CHANGE BULLETIN 01

F.G.A. No. 21003

ROOMS TO GO – OFFICE RENOVATION & EXPANSION

January 20, 2022

SHEET NUMBER
E2.10B

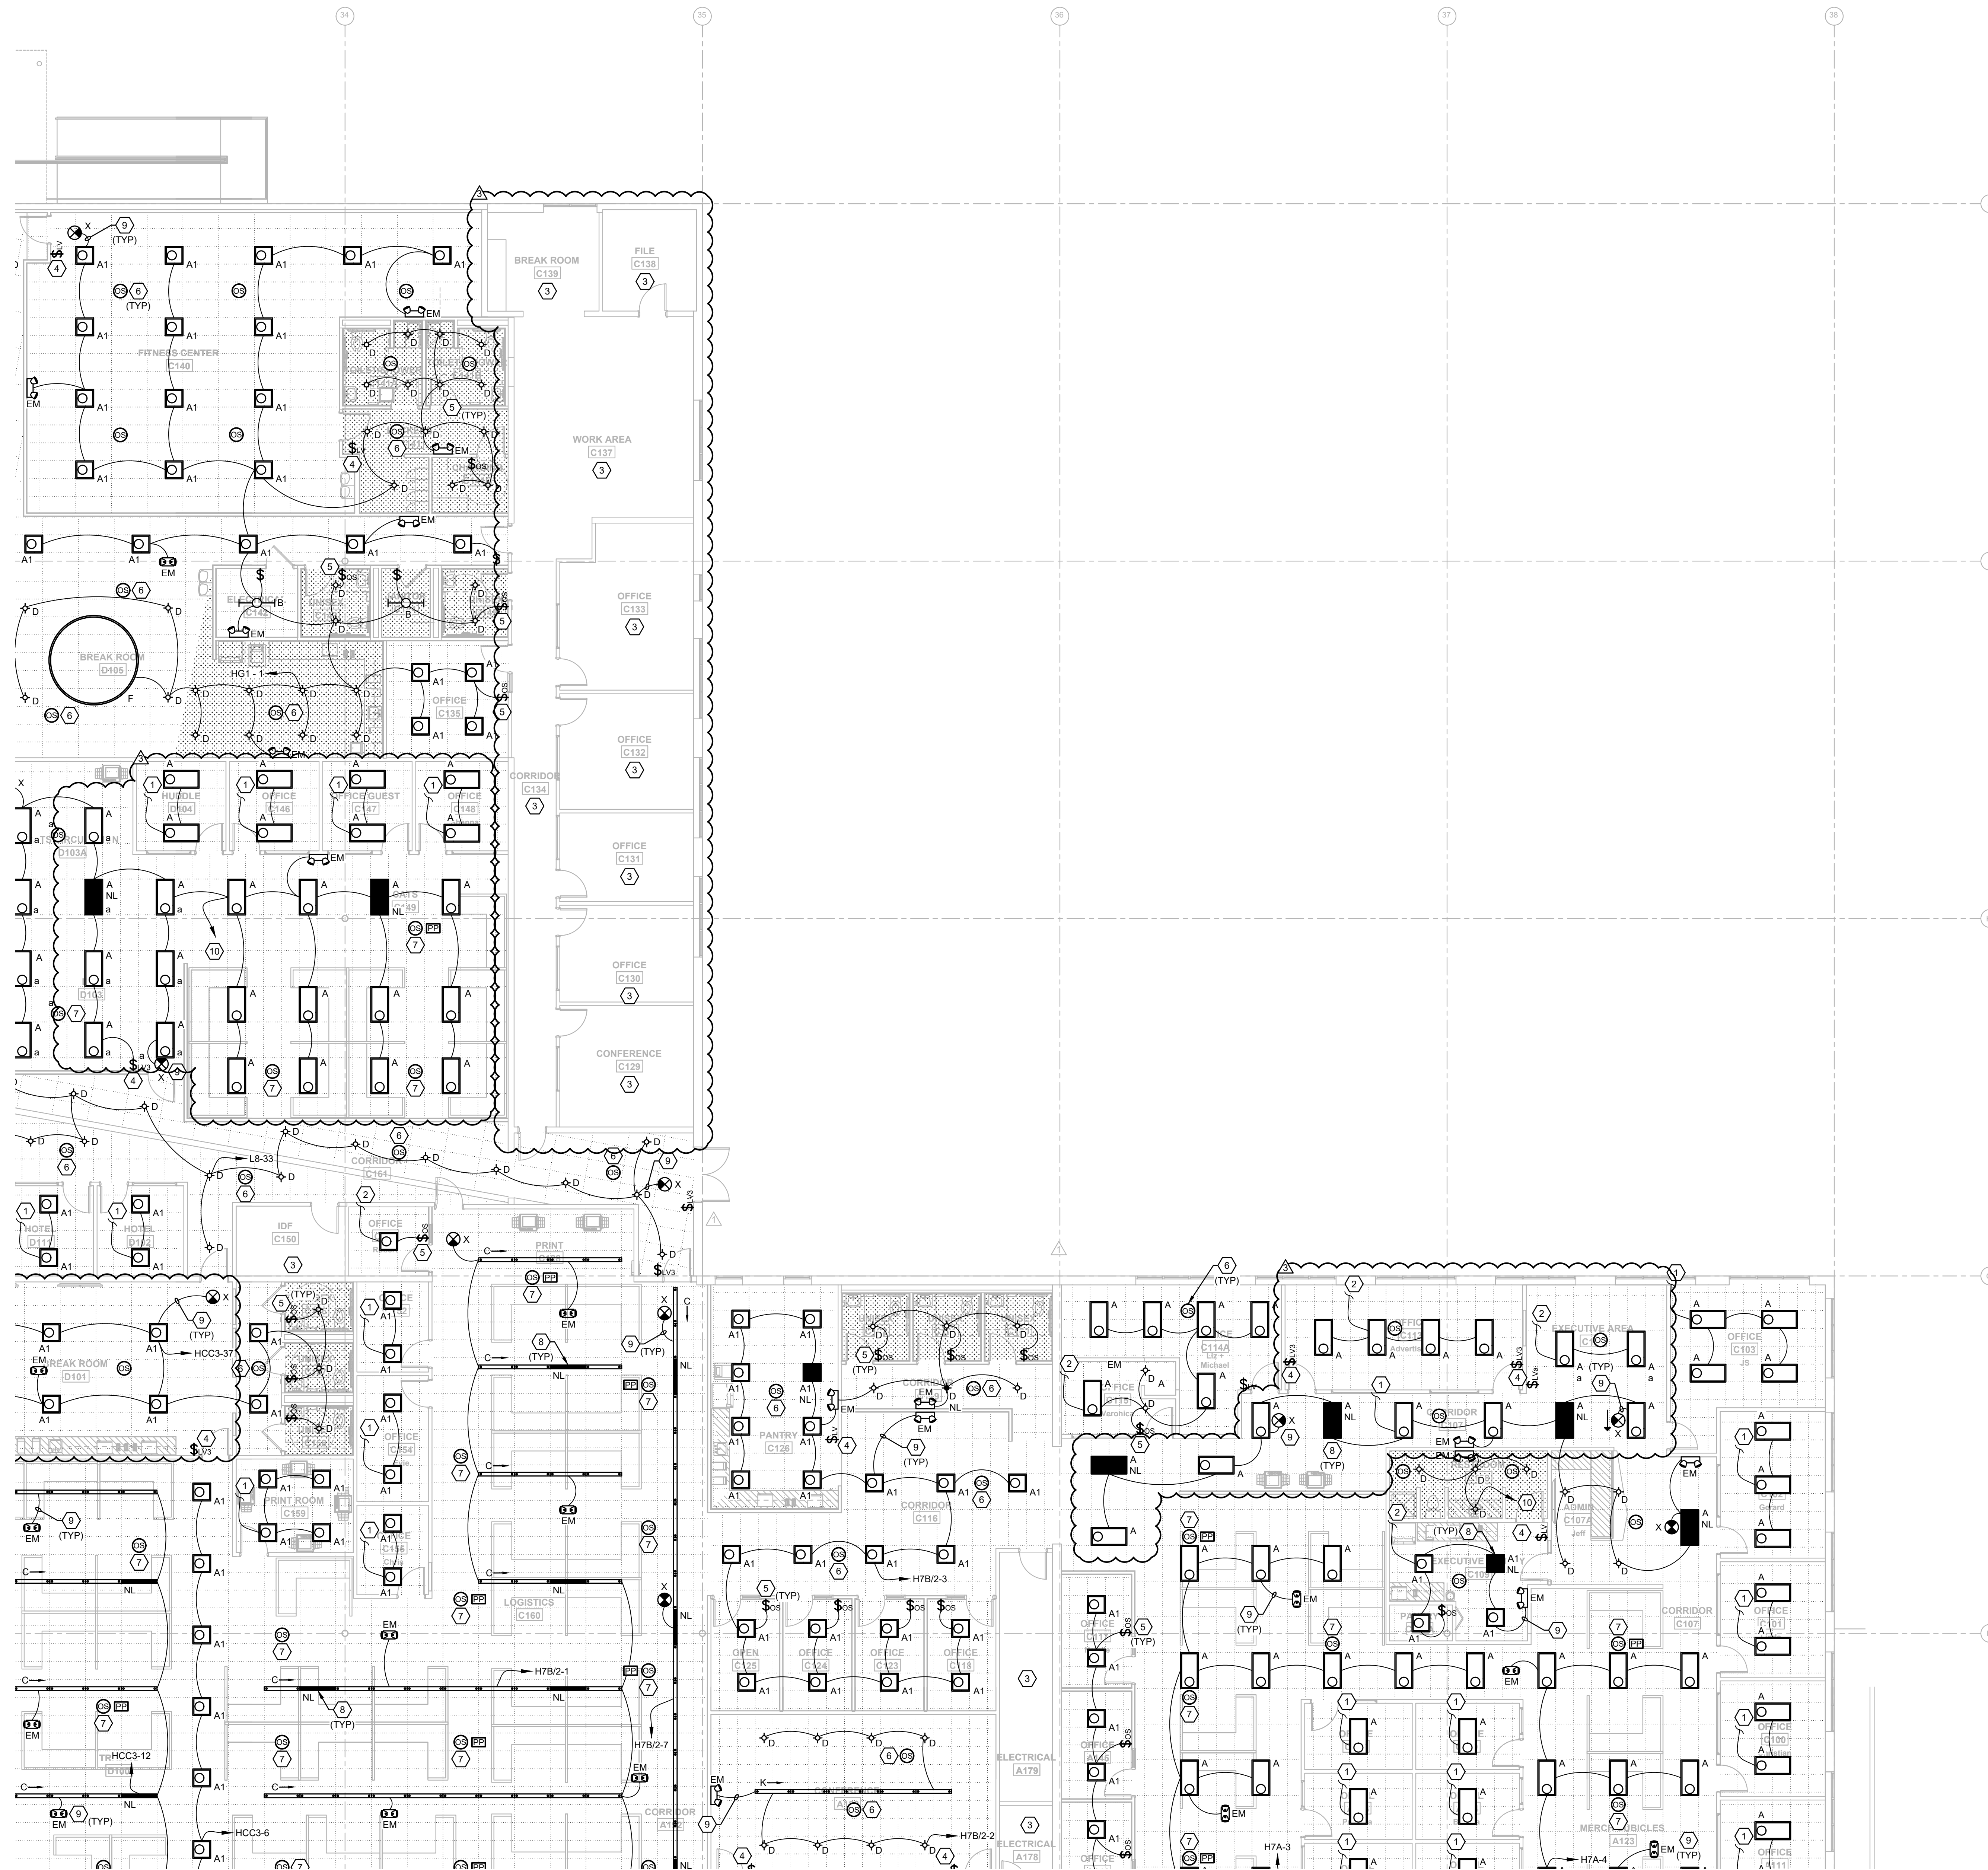
Dwg No	Description	Remarks
		<ul style="list-style-type: none"> • Shifted 2x2 troffers in Corridor A126 per architectural RCP • Adjusted 2x2 troffer to grid outside File Room A221 per architectural RCP
E2.10B	LIGHTING PLAN – B	<ul style="list-style-type: none"> • Adjusted downlights to center of grid tiles in Conference B103 per architectural RCP • Overlap with Area A outside File Room A221 • Adjusted 2x2 troffer to grid near Accounts Payable B105 per architectural RCP • Shifted linear fixtures in wider section of Corridor A202 to center of wider section per architectural RCP • Overlap with Area A in Corridor A202 changing linear fixtures to downlights per architectural RCP • Added downlight at end of Corridor A202 per architectural RCP • Added downlights in Waiting B166 per architectural RCP
E2.10C	LIGHTING PLAN – C	<ul style="list-style-type: none"> • Updated lighting layout to new floor plan of Advertising Office C113, Executive Area C105, and Corridor C107 • Removed lighting from scope in Conference C129, Offices C130, C131, C132, C133, Corridor C134, Work Area C137, File C138, and Break Room C139 • Added and adjusted 2x4 troffers in Lab D103, and Cats Circulation D103A per architectural RCP • Shifted 2x4 troffers in Cats C149 per architectural RCP • Adjusted 2x4 troffers to grid in Offices C146, C147, C148, and Huddle D104 per architectural RCP • Shifted 2x2 troffers in Break Room D101 per architectural RCP

SHEET NUMBER
 E2.10D

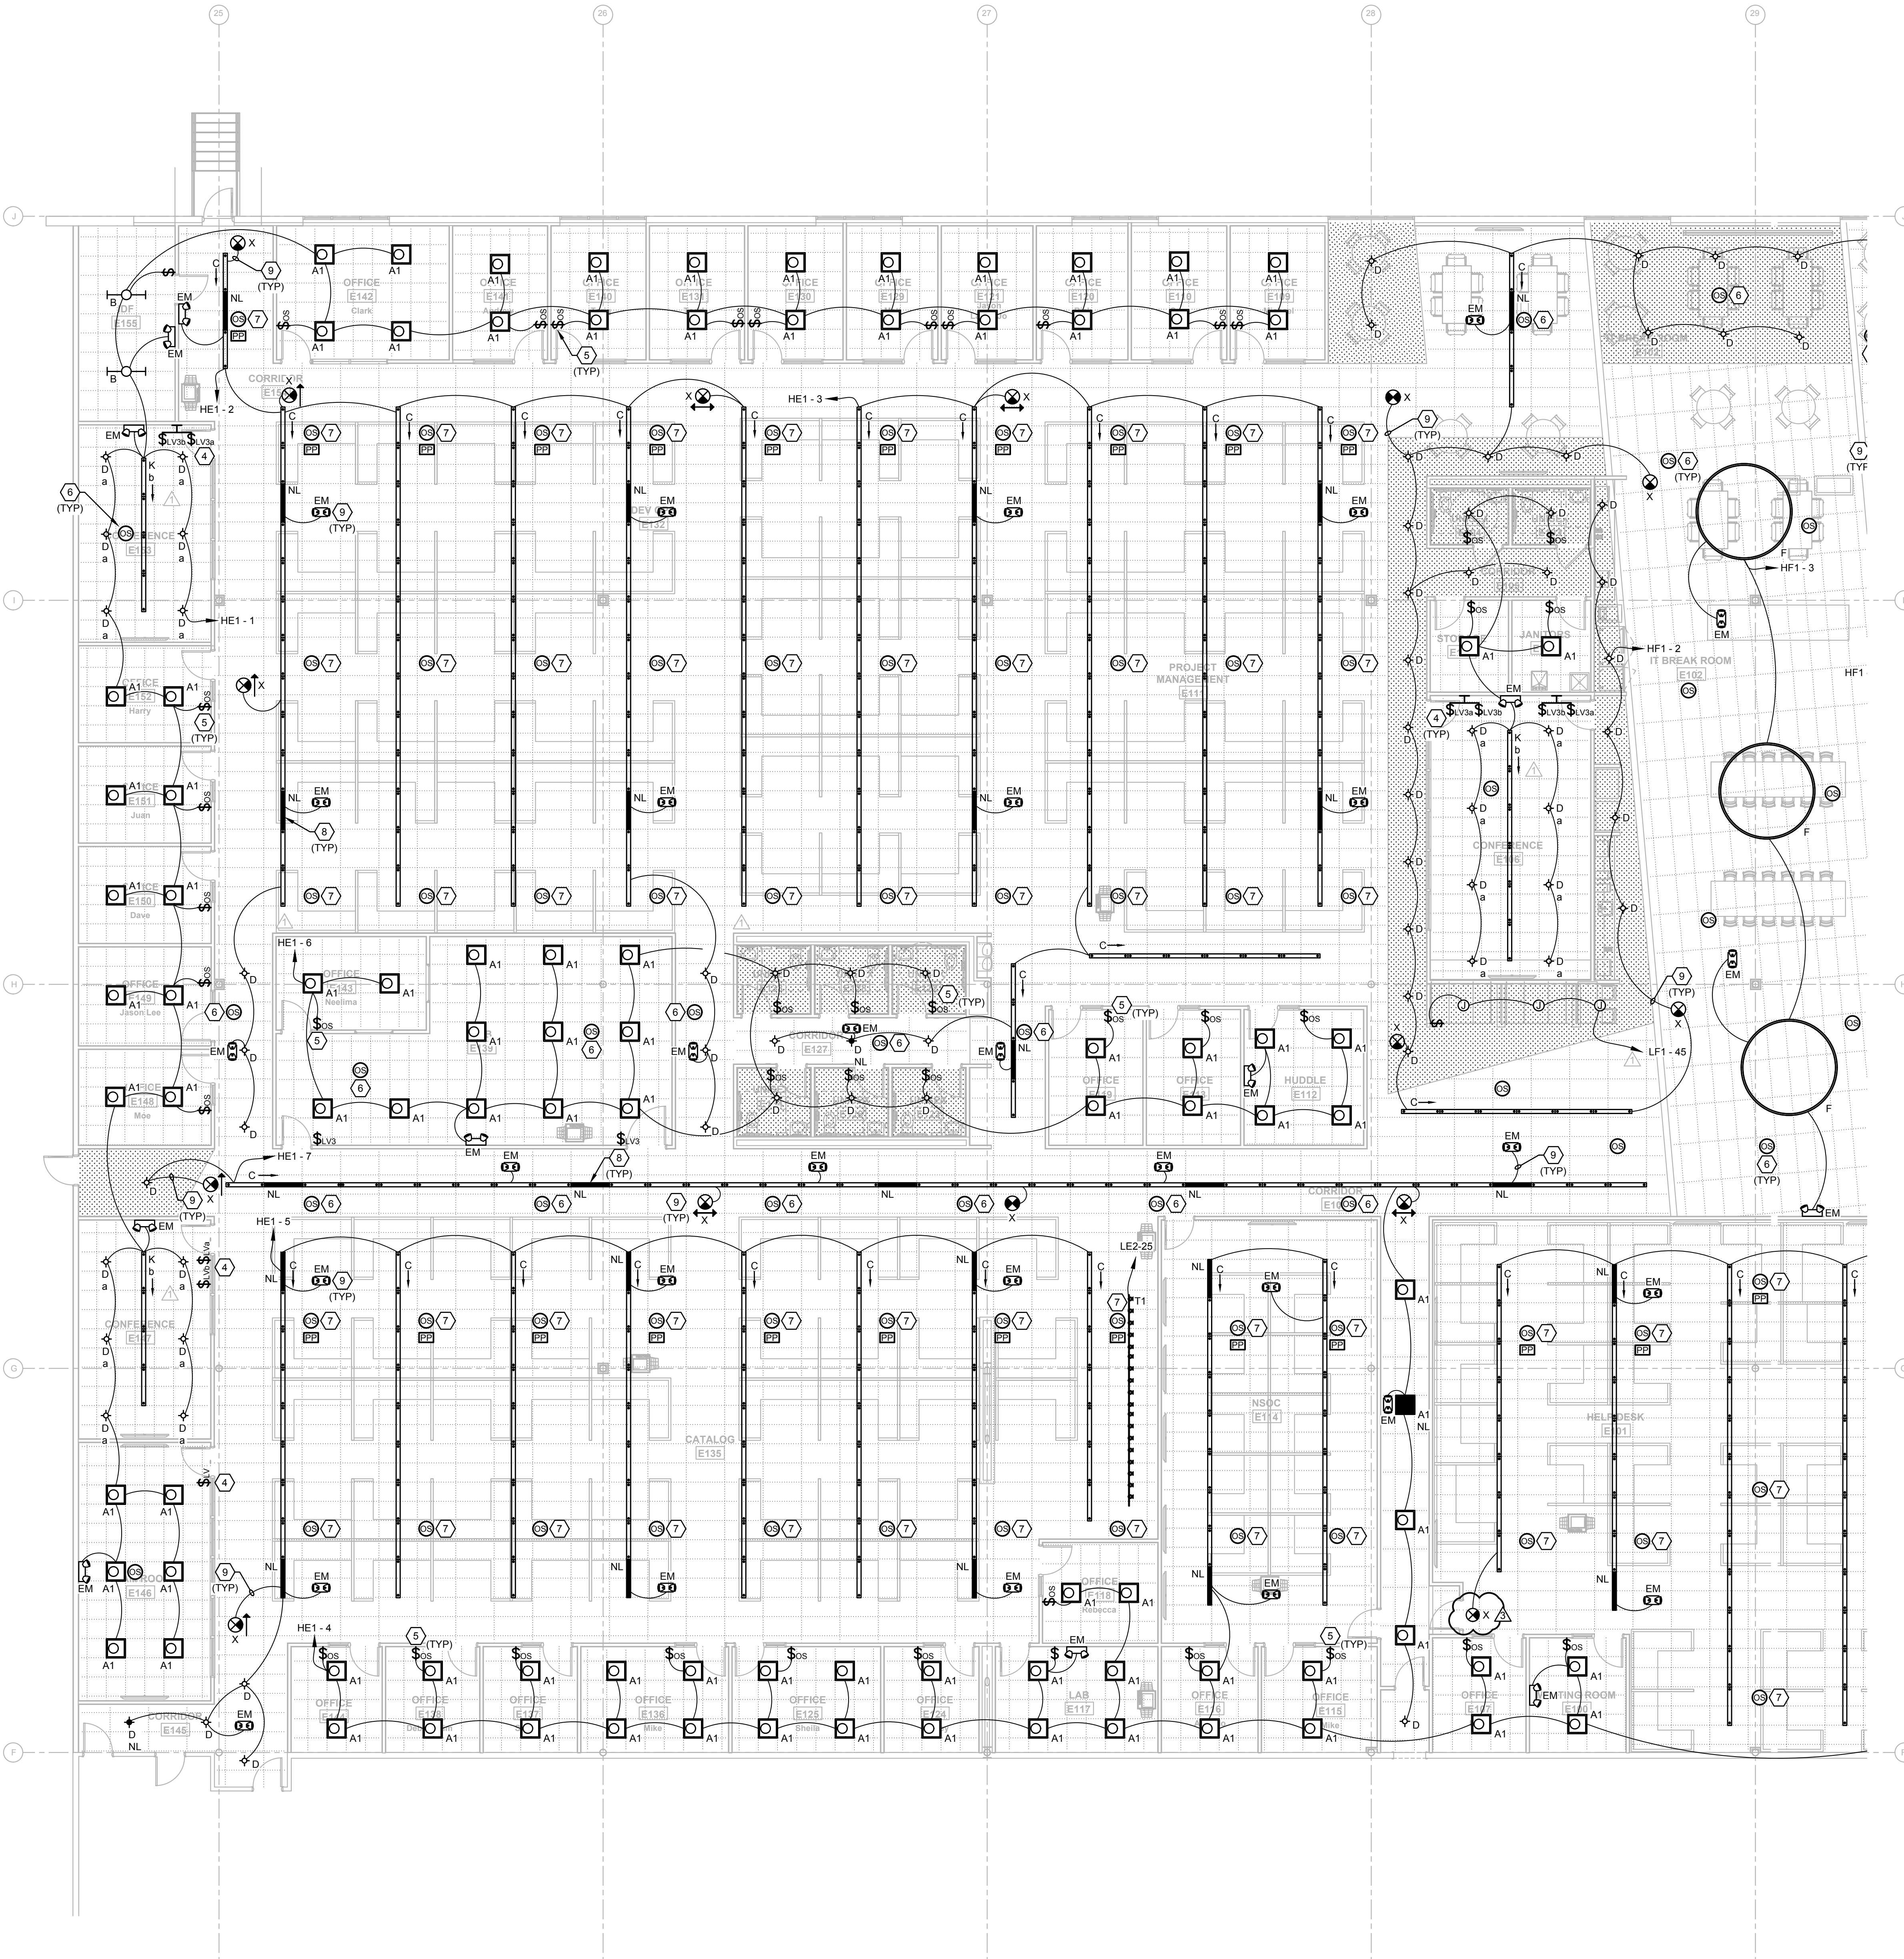
E2.10D	LIGHTING PLAN – D	<ul style="list-style-type: none"> • Overlap with Area C in Cats C149, Offices C146, C147, C148, Huddle D104, Lab D103, and Cats Circulation D103A • Overlap with Area C in Break Room D101 • Shifted linear fixtures to center of Corridor D148 per architectural RCP • Added circuit grouping and circuits clarified in RFI#5 for Offices D117 and D118, War Room D119, Purchasing Storage D109, Infrastructure D125, Office D137, Huddle D138, Network Mgmt D139, and open office area adjacent to D137 • Added downlight near Breakroom D105 per architectural RCP • Added exit sign in Help Desk E101 per architectural RCP
